Re: **NONCOMPLIANCE NOTIFICATION**

Administrative Compliance Order and Request for Information CWA-02-2013-3032 And Transmittal of Report from August 28, 2013 EPA Reconnaissance Inspection. United Talmudical Academy of Kiryas Joel - Bakertown Road, Village of Kiryas Joel, NY NPDES Tracking Number: NYU400900

Attachment 1 - Photographs of United Talmudical Academy of Kiryas Joel on August 28, 2013. Taken by Murray Lantner, P.E., Environmental Engineer, Nikon Coolpix P510, EPA Region 2, DECA-WCB

UTA of KJ Boy's School Construcdtion Site Attachment 1

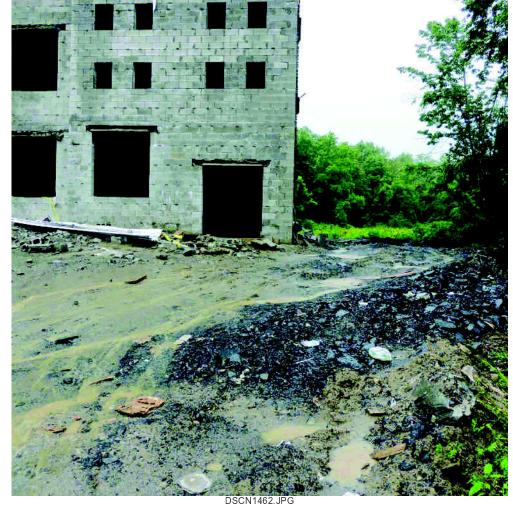
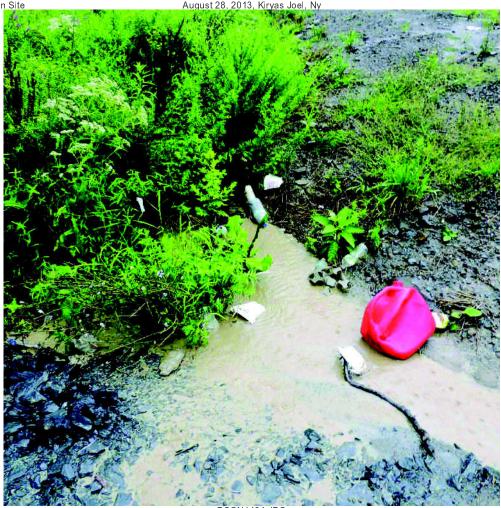
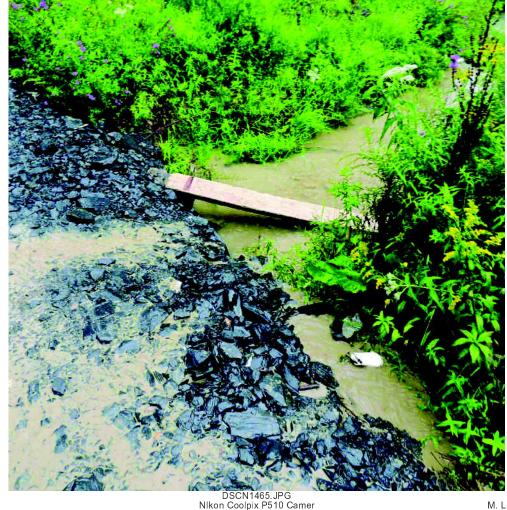
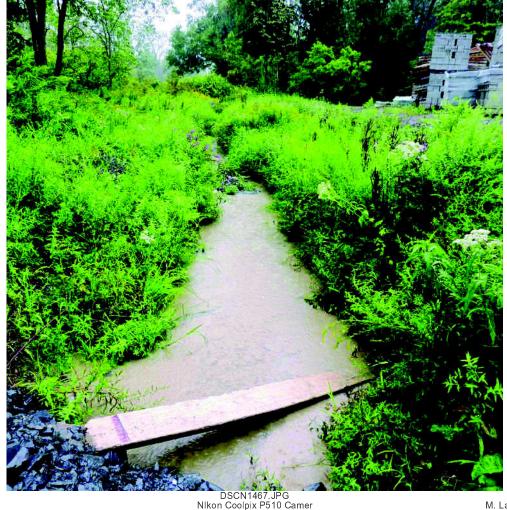
- Entrance road to UTA of KJ Boys School was built across the Highland Brook at the southwest area of the site. Culverts are used to convey the stream from one side of the road to the other. During this inspection, a heavy rain event occurred in Kiryas Joel. EPA observed, turbid run off from the site into Highland Brook at this location. See Photos and Videos 1450 to 1450 in Attachments 1 and 2.

- 2. At multiple portions around the perimeter of the site, the silt fence was improperly installed. The silt fence was not buried into the ground as required and material from the site was able to freely flow beneath the silt fencing. (See Photos/Videos 1455 to 1459) Turbid flows from these point sources were able to enter Highland Brook and its tributary. The silt fences need to be properly installed and maintained in order to prevent discharge of sediment from the site.

- 3. Turbid discharges are seen discharging from the site, but mainly around the site entrance see photos in Attachment 1 and videos in Attachment 2. The heavy turbid discharge from

the site caused a plume of sediment within Highland Brook. This plume can be seen flowing steadily downstream from the site in Highland Brook. The plume was documented initially beginning at the site entrance road as shown in Video 1460 (Attachment 2) and Photo 1461 and then continuing downstream (See Photos and Video 1450 to 1454, Video 1460, Photo/Video 1464 to 1470). Adequate stormwater best management practices must be installed on and around the site entrance as well as upgradient of the site entrance to reduce the volume, velocity and pollutant loads in the site runoff.

- 4. New York State Narrative Water Quality Standards in NYCRR Part 703.2 (http://www.dec.ny.gov/regs/4590.html#16133), applicable for Highland Brook a Class C stream, specify that: there can be no increase in turbidity that will cause a substantial visible contrast to natural conditions; and, that there can be no suspended, colloidal or settleble solids from sewage, industrial wastes or other wastes that will cause deposition or impair the waters for their best usages. UTA of KJ's turbid discharges do not conform with the New York State Narrative Water Quality Standards.
- 5. As shown in photos/videos 1455 to 1459 silt fencing at the northwestern portion of the site was not buried into the soil as required. There were flow paths shown below the silt fencing.
